ARKANSAS NUCLEAR ONE - UNIT 1

IMPROVED TECHNICAL SPECIFICATIONS SUBMITTAL

**03/19/01 Supplement
Volume 2 of 2
(Sections 3.9, 4.0, and 5.0)**

Figure 4.18.1

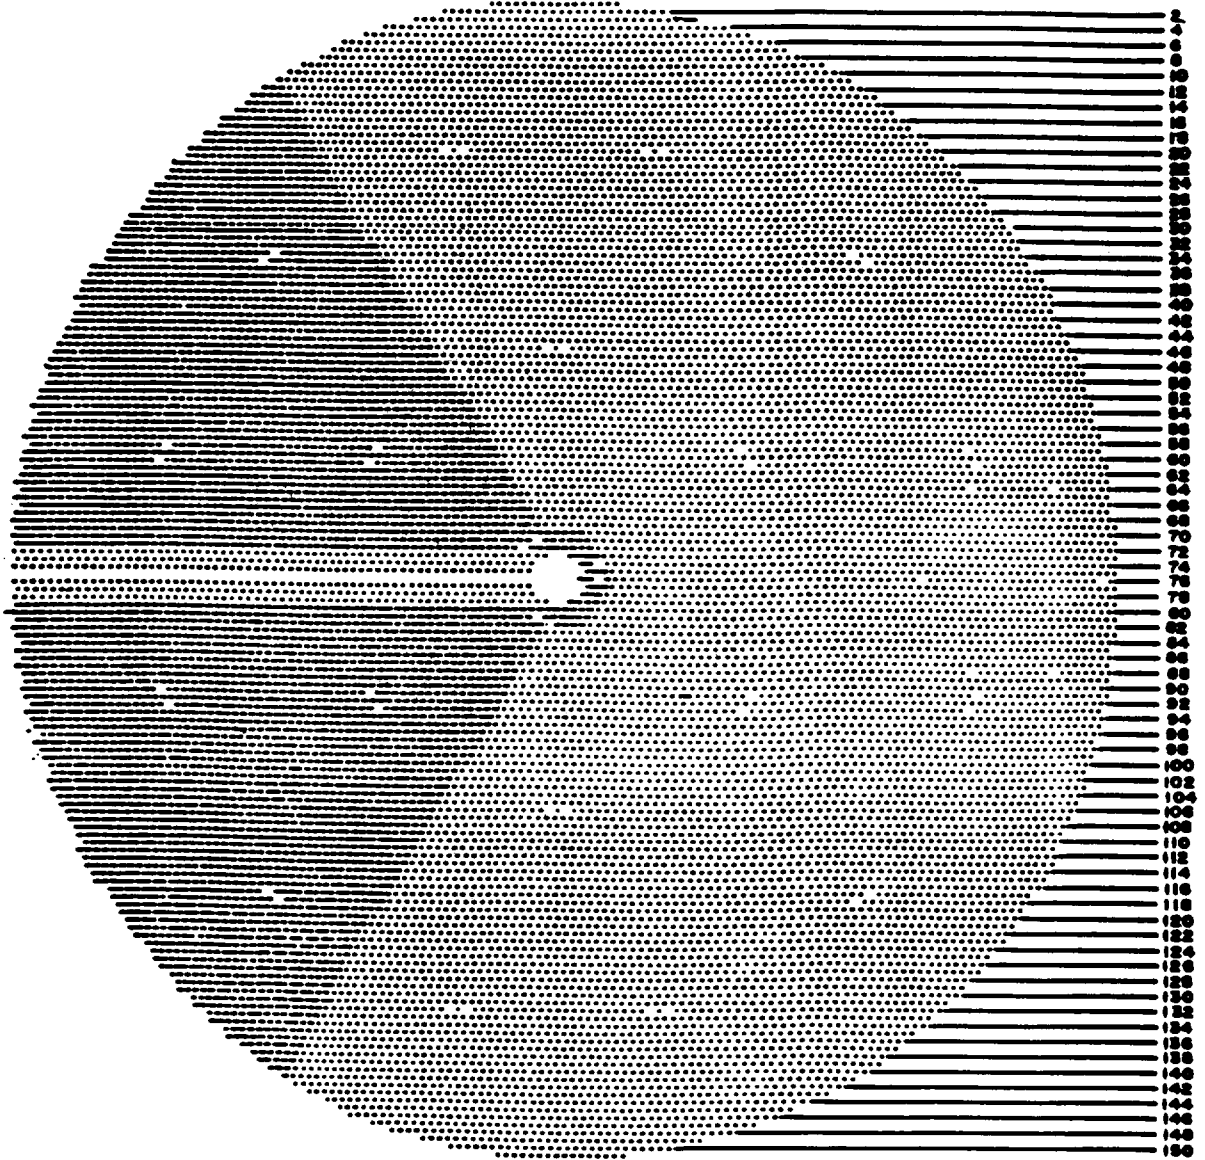
NOTES: ¹ S=3N Where N is the number of steam generators in the unit, and n is the number of steam generators inspected during an inspection. ~~5.5.9.C.1.iii~~

² For tubes inspected pursuant to ~~4.18.3.a.3~~: No action is required for C-1 results. For C-2 results in one or both steam generators plug, reroll, or sleeve defective tubes. For C-3 results in one or both steam generators, plug, reroll, or sleeve defective tubes and provide a Special Report to NRC pursuant to ~~6.12.5.d~~.

FIGURE 3.2 4-1

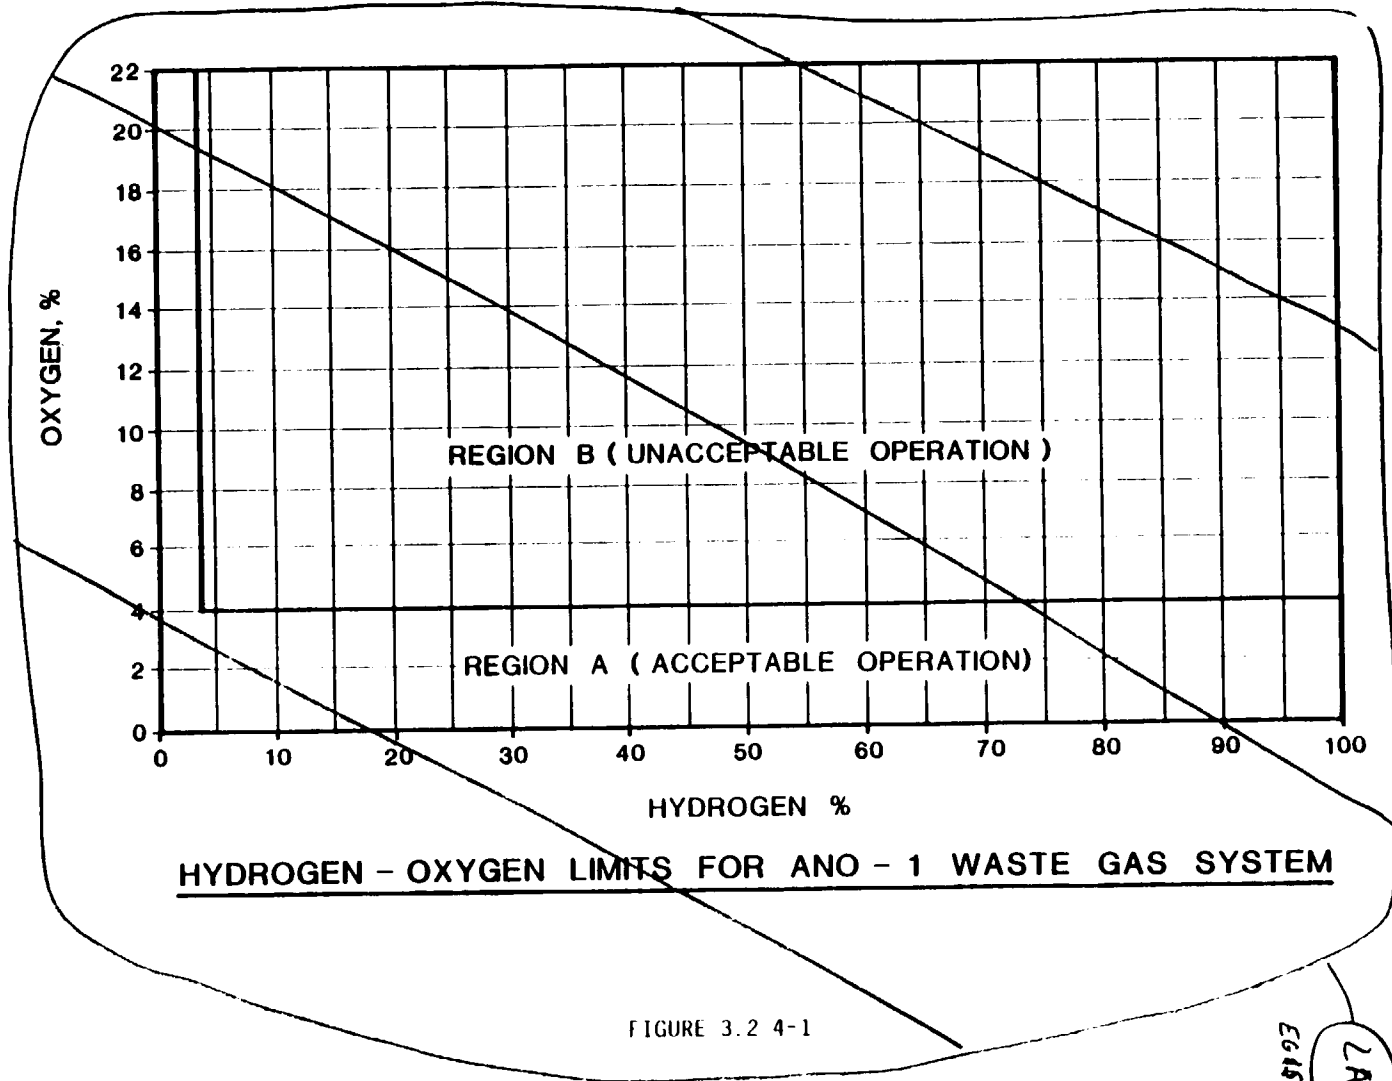
A2
